Amendments to the Drawings

FIG. 3

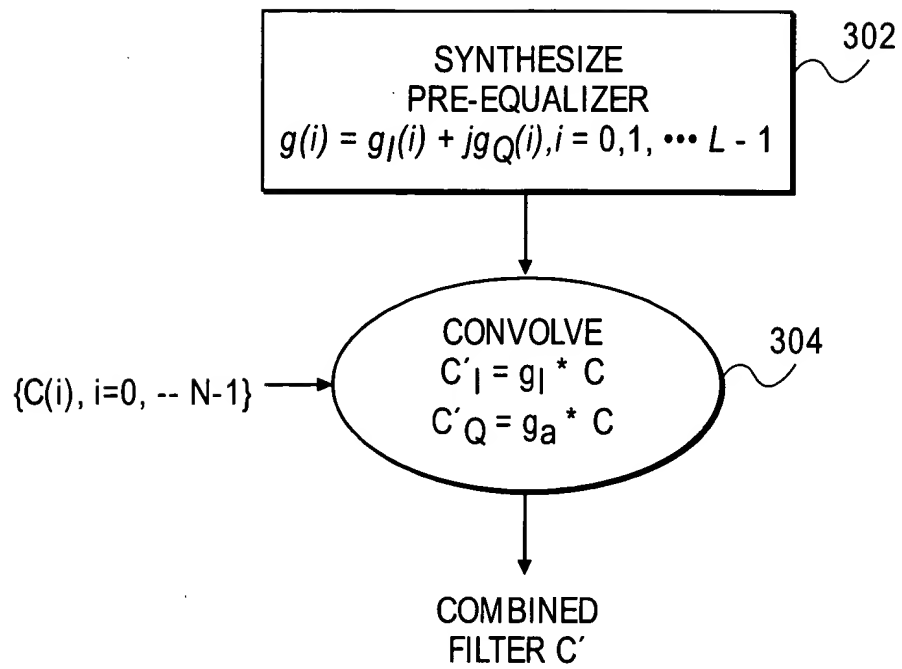
Replacement sheets for Figs. 3 and 4 are attached. Fig. 3 is amended by including in box 302 the relationship $g(i) = g_I(i) + jg_Q(i), i = 0, 1, \dots, L-1$ and deleting $\{g_I(i), g_Q(i), i = 0, 1, \dots, L-1\}$. Fig. 4 is amended by identifying the dashed box by numeral 408 instead of 406.
